From: Sent: 20 September 2018 16:52 To: john.diver@camden.gov.uk. Cc: 2018/3539/P 9a Daleham Mews London NW3 5DB Subject:

This application fails at the rear on distance and overlooking as it will give direct views into the habitable rooms of 13 15 17 & 19 Belsize Crescent this application if approved will add to the cumulative impact of sense of overbearing enclosure of what little private space remains at the rear of the above properties.

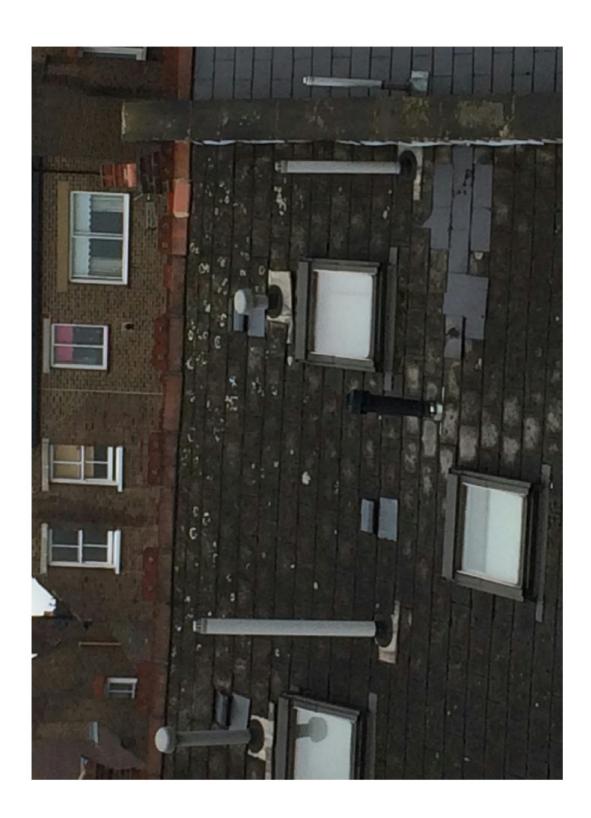
XUL Architects say "The balcony at the rear will have direct access from the first floor. Due to the high parapet wall at the rear of the site boundaries, there will be minimal views of the proposed alterations to the neighbouring properties" but in reality the parapet wall to the proposed terrace is no more .86/.87 of a metre, this can be picked from the proposed rear elevational drawings, the simple way to understand this is to compare the height of the doors and the parapet wall. It should also be noted that 9a abuts number 9 if standing on the proposed terrace it would be possible to look down through the Velux windows of number 9 which would provide a angled direct view into the small bedroom of number 9.

floor of Belsize Crescent which clearly shows the extent of See photograph below taken from the the overlooking.

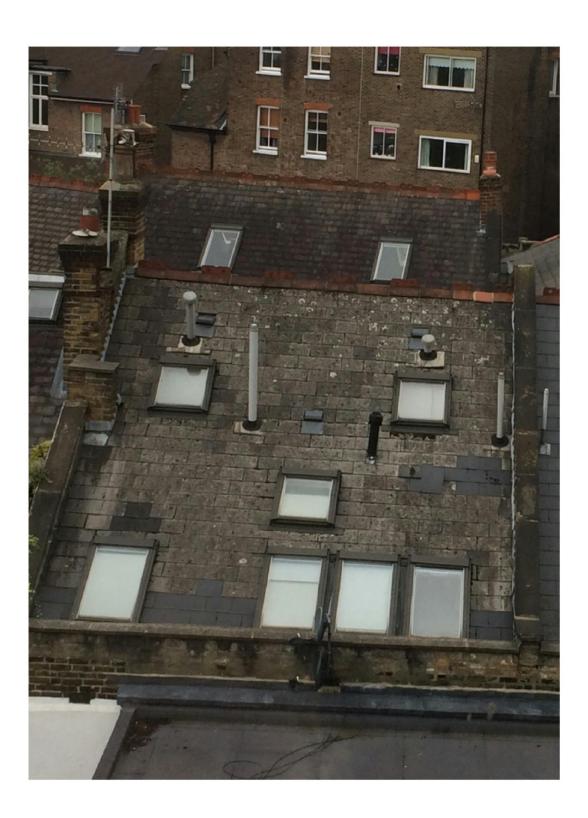
The photograph below shows the same close aspects from the 1st floor of Belsize Crescent.

Below is a view of Dalcham Gdns to the left of photograph and Dalcham Gdns to the right, this illustrates the over looking from DG.
